Service-Information

Group 13 Fuel Supply & Adjustment	May 1980	Bulletin No.: 13 003 80(2021)
--------------------------------------	-------------	----------------------------------

Subject: Air Intake Modification for all 1980 Models

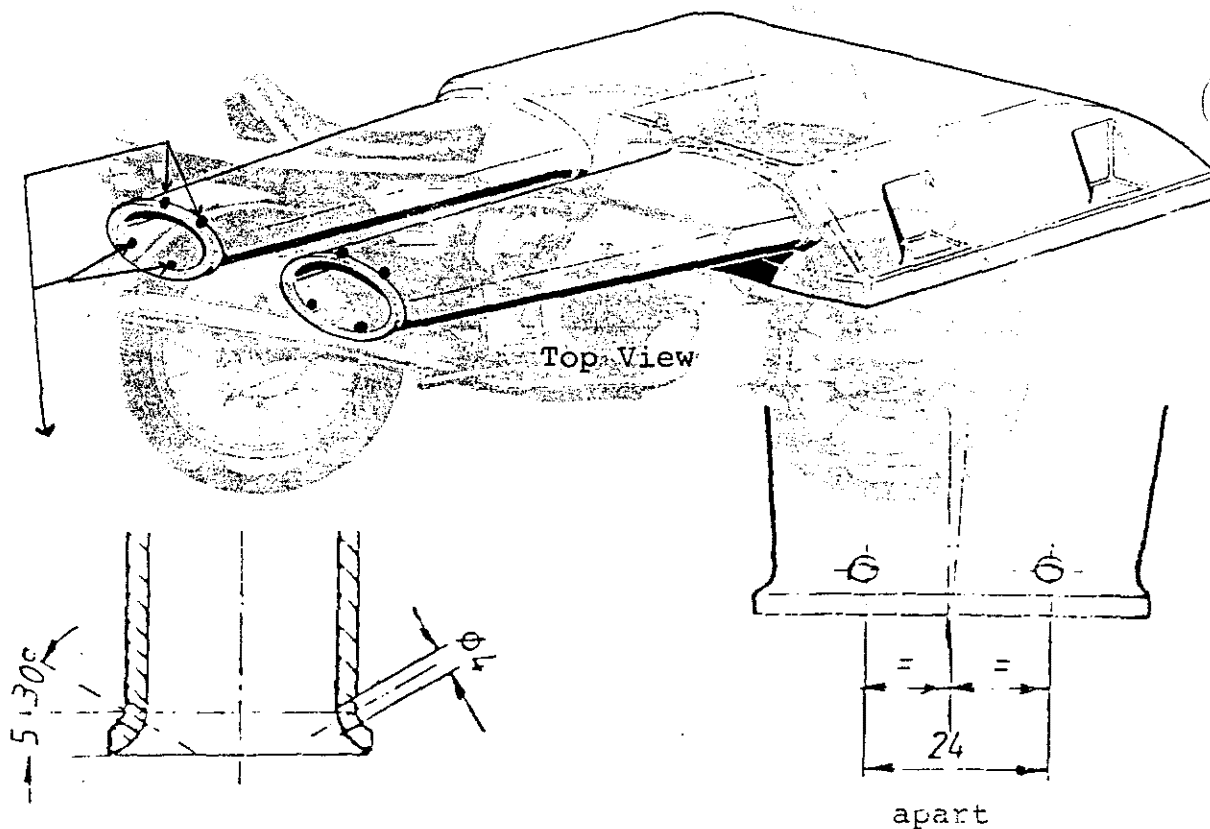
Subsequent to the start of 1980 model production, it was discovered that a modification to the air filter housing top was beneficial to the air intake/carburetion systems.

The modification consists of drilling four (4) holes in each air horn as indicated in the drawing below.

at a 30° angle
5 mm from the edge

Motorcycles lacking this modification may experience a mid-range flat-spot in the carburetion as the restricted air intake creates an overly rich condition in the combustion chamber.
